1 **ADDENDUM NO. 1**  
2 **ISSUE DATE: August 12, 2024**

3  
4  
5 **RE: PRIMATE CENTER BACK-UP GENERATOR**  
6 **University of Wisconsin – Madison**  
7 **Madison, Wisconsin**  
8 **MSN Project No. 0526-1703**  
9 **UWSA Project No. A-17-033**

13  
14 **FROM: Mead & Hunt, Inc.**  
15 **2440 Deming Way**  
16 **Middleton, WI 53562**

Sheet Title:  
 GENERATOR ROOM PRECAST & FLATWORK PLANS

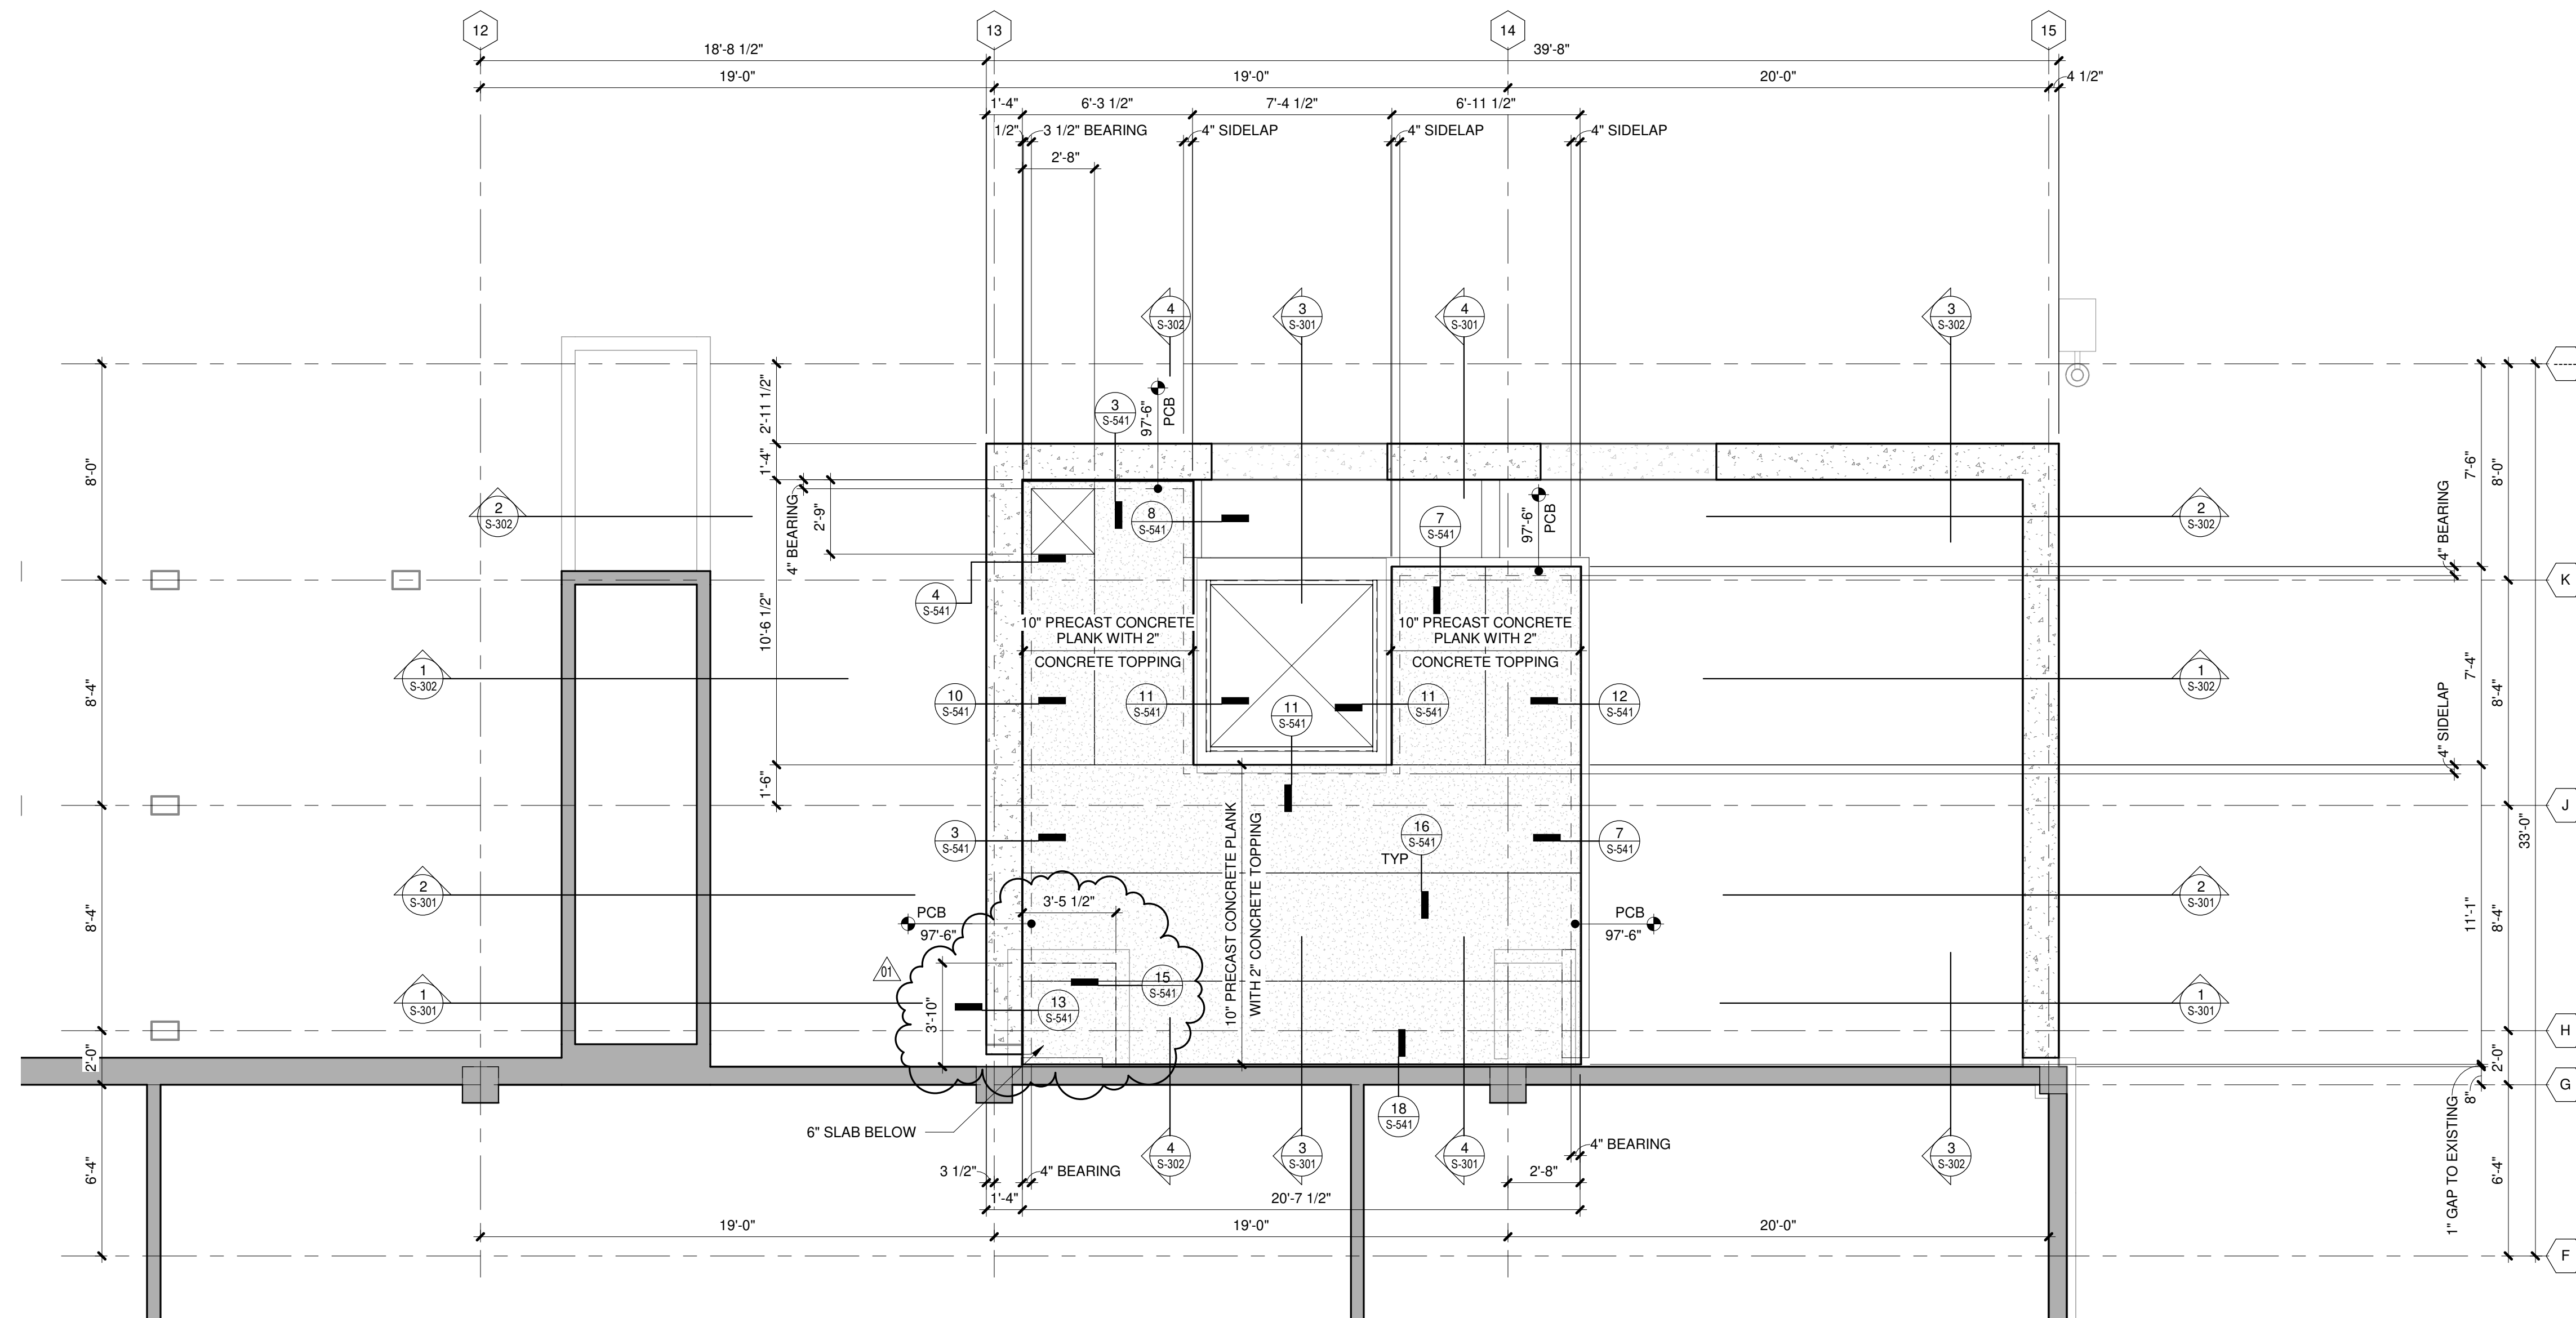
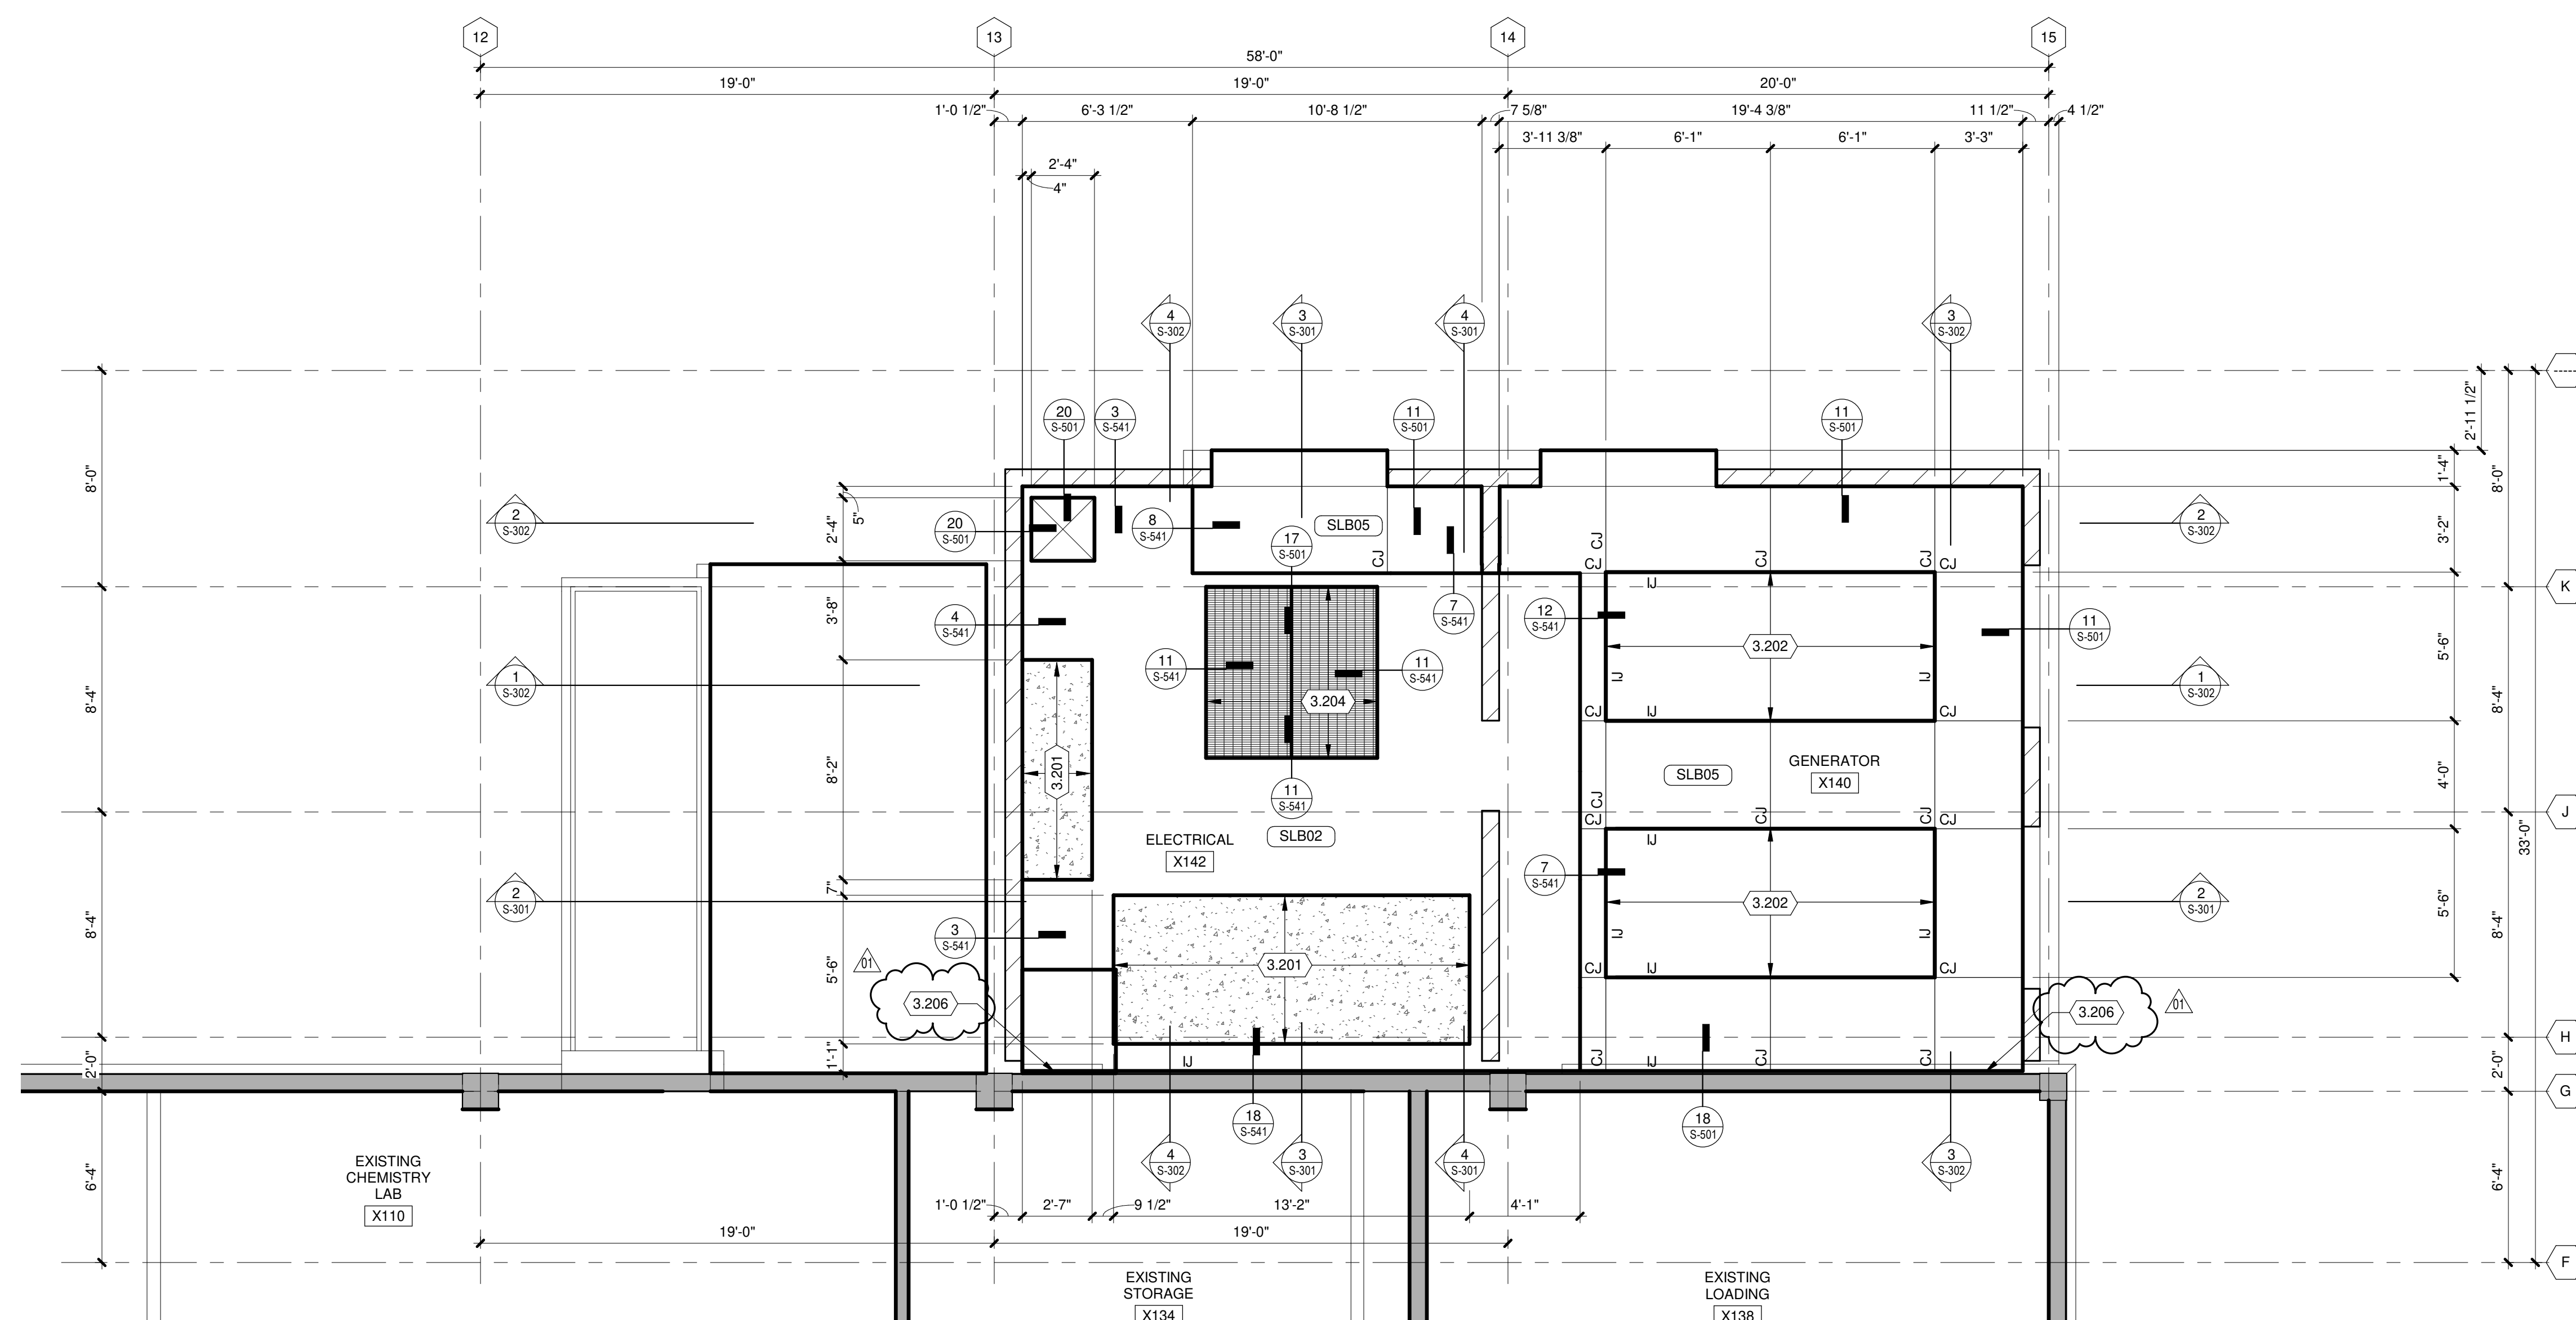
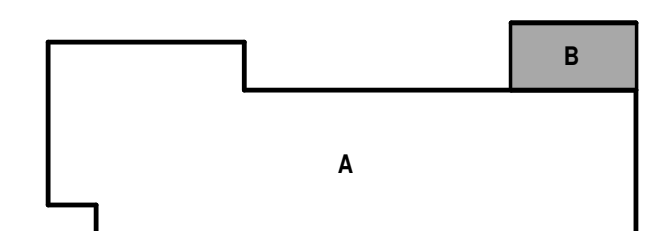
- 36 ▪ Response 2: This is clarified within drawing revisions of this addendum.
  - 37 ○ Question 3: Please clarify untagged walls that terminate at existing foundation on structural  
38 grid line G.

7 2. SHEET S-102: GENERATOR ROOM PRECAST & FLATWORK PLANS

- 39 ▪ Response 3: This is clarified within drawing revisions of this addendum.
  - 40 ○ Question 4: Elevation 9 on page S-521 note references sheet S-131 regarding structural wythe  
41 joint locations, however sheet S-131 does not exist. Please provide this page or clarify  
42 structural wythe joint locations.

8 a. Revise as shown clouded within attached sheet S-102.

**13 MASONRY WALL ISOLATION JOINT**  
 1 1/2" = 1'-0"

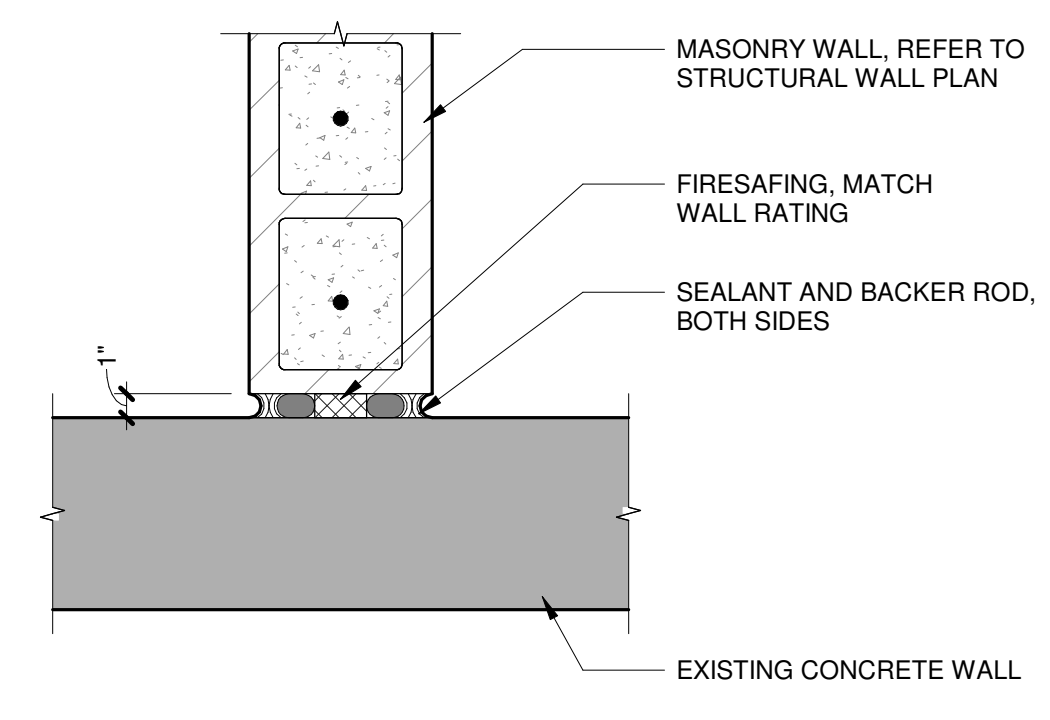
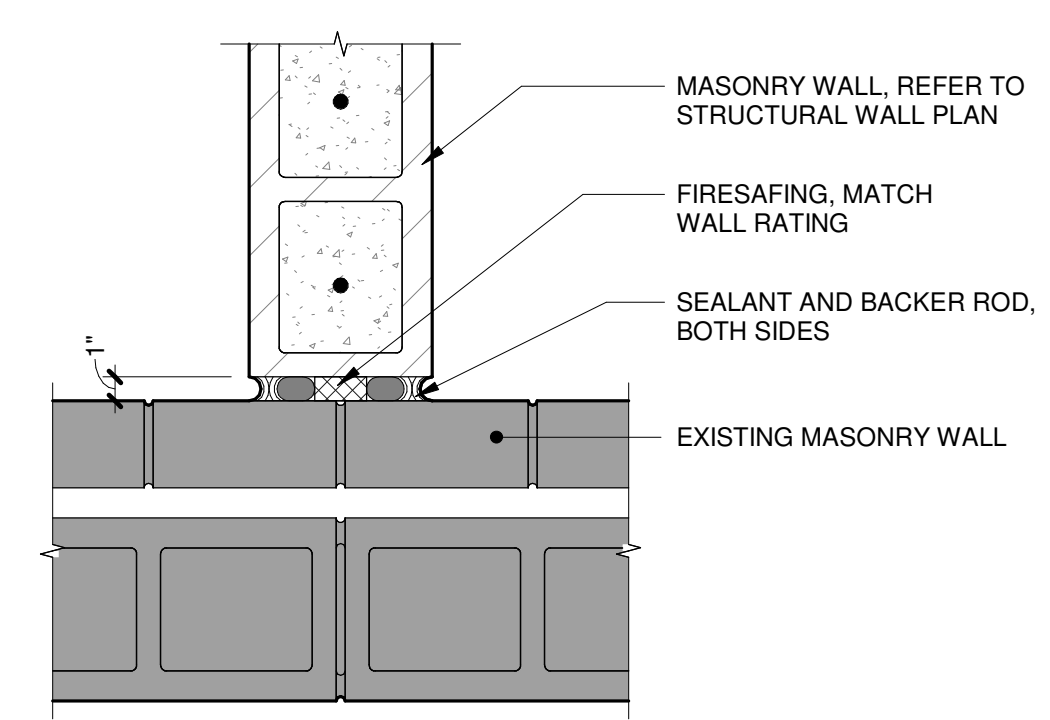
- 32 ▪ Response 1: No geotechnical report was procured for this project. There are soil  
33 borings on the original building design drawings.
  - 34 ○ Question 2: Please clarify extents of concrete infill slab noted in section views 13 and 15 on  
35 S541. No infill slab is noted on structural floor plans S101 or S102 that match these details.

9 3. SHEET S-521: STRUCTURAL WALL DETAILS

10 a. Revise as shown clouded within attached sheet S-521.

**9 TYPICAL MULTI-WYTHE MASONRY CONTROL JOINT**  
 1 1/2" = 1'-0"

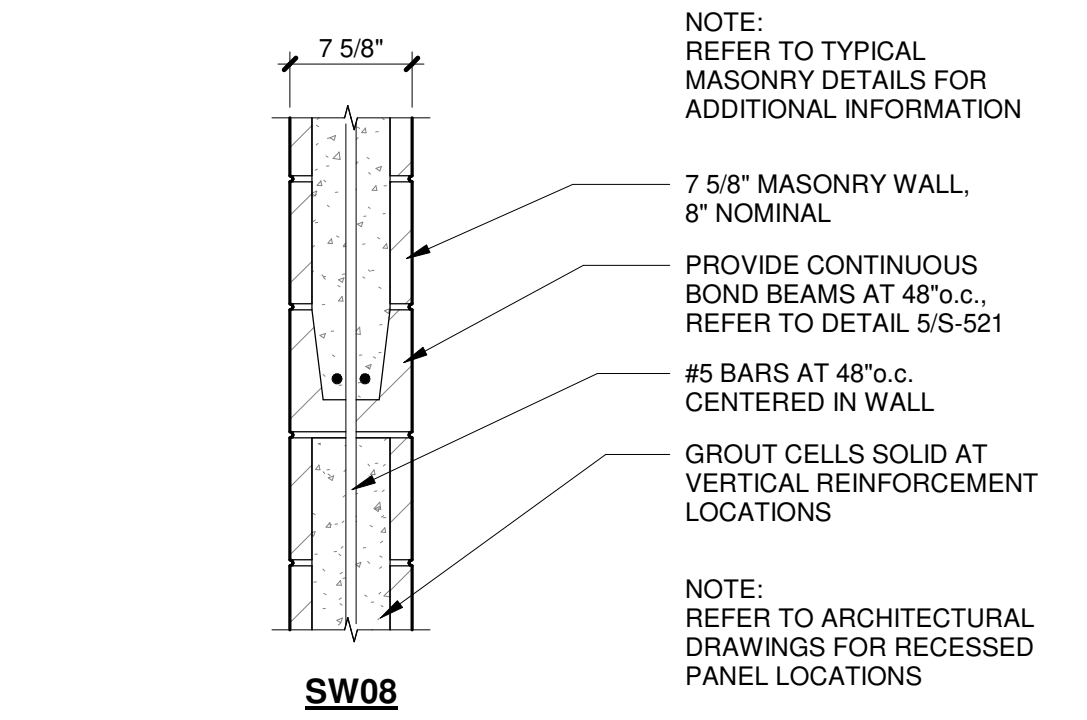
- 48 ○ Question 5: Please confirm desired continuous masonry joint reinforcement type for exterior  
49 veneer is tri-rod and not hook & eye. Spec Section 04 20 00 calls for units equivalent to  
50 Hohmann & Barnard, Inc. #130, while Elevation 9 on page S-521 shows Hohmann & Barnard,  
51 Inc. #120 with single screw style veneer ties.

- 43 ▪ Response 4: CMU control joint locations are shown on Plan View 1/S-103 with  
44 diamond symbols. Brick veneer control joints are shown on Architectural elevations.  
45 Brick joints do not need to coincide with CMU joint locations. Sheet S-131 does not  
46 exist. Note has been amended to refer to Plan View 1/S-103 within drawing revisions  
47 of this addendum.

- 52 ▪ Response 5: Provide two rod horizontal joint reinforcement, and hook and eye brick  
53 ties as shown on 9/S-521. Specifications has been updated accordingly within this  
54 addendum.
